Wiltshire Council Planning Consultation Response

Application No: PL/2026/01029
Retrospective Application for replacement/ modified/new/windows and doors, internal works to include new partitions, staircase, recovering of roof surfaces and associated works
Penleigh Farm, Fairwood Road, Dilton Marsh, Westbury, BA13 4EB

Both taken from the Carter Jonas website - [Farm for sale in Penleigh, Fairwood Road, BA13 : Bath : BTR230014](#)

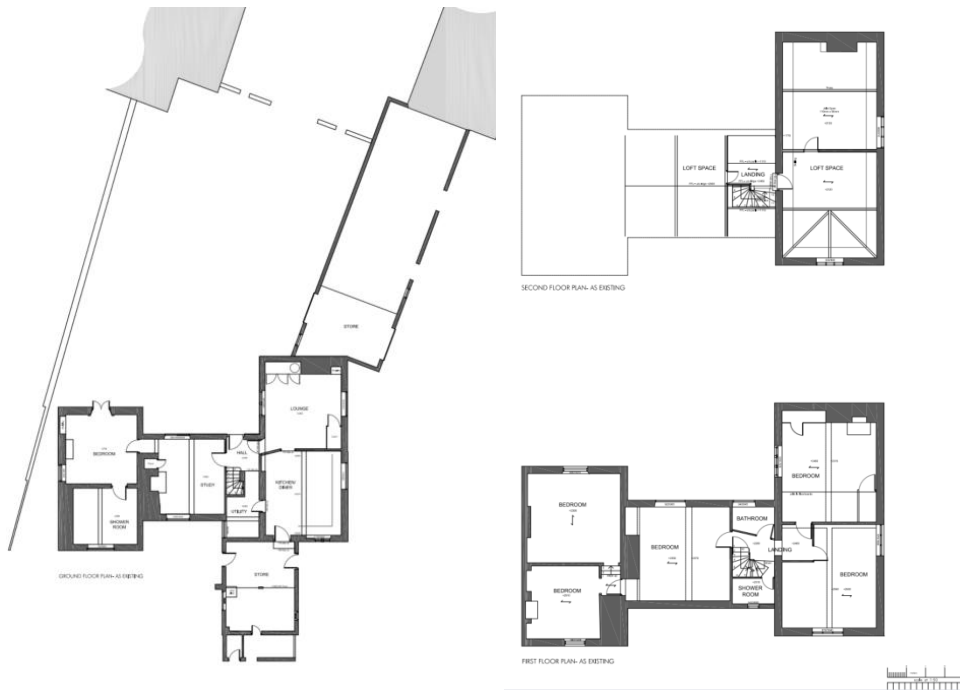
It is understood that the property had been vacant for a number of years, and has been subject to arson attacks. The sales details provide some images on the condition of the property. This shows that there was issues of rot, presumable from water ingress and poor maintenance. As part of the application, a Photographic Survey was provided. This shows that some fire surrounds were removed, some glass in the windows is smashed, or boarded, that there are localised areas of damage through arson and that some

stripping out has occurred. However, there remains some architraves, skirting boards, plaster (and wall paper) on walls and plaster finish to the ceilings, and complete floors and some fire surrounds. It is acknowledged that the building was not habitable at the time of purchase, and that works were required to bring the building back to a habitable condition.
